Title Front Accessory Drive Noise, Alternator Belt Wear, Alternator Belt Tensioner Failure -  
Model Year 2017 And Newer

**\*\* SOLUTION \*\***

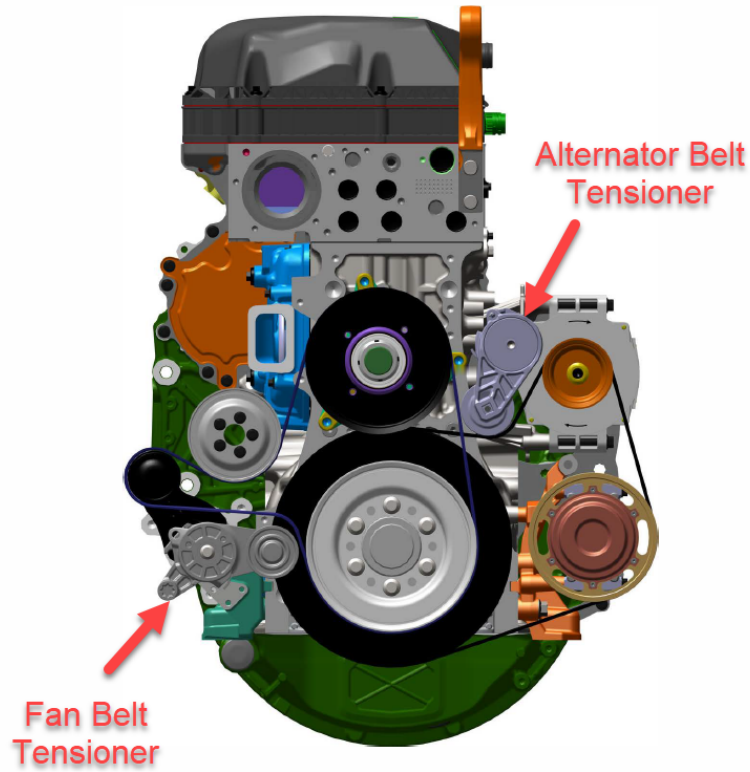
**Cause** Vehicles manufactured for Model Year 2017 and newer may experience excessive noise originating from the accessory drive belt and pulleys. Noise may be accompanied by excessive belt wear or alternator belt tensioner failure.

It has been determined that these issues were caused by a flaw in the alternator belt tensioner itself.

**Solution** An improved version of the alternator belt tensioner, Part Number [23669029](#), has been released to address this issue.

The new tensioner design is for model year 2017 and newer trucks equipped with either an 11 liter or 13 liter engine.

**NOTE:** Part Number [23669029](#) is ONLY for the Alternator Belt Tensioner, it is **NOT** compatible for the Fan Belt Tensioner. If a fan belt tensioner is needed, order the current part listed in [Impact](#).
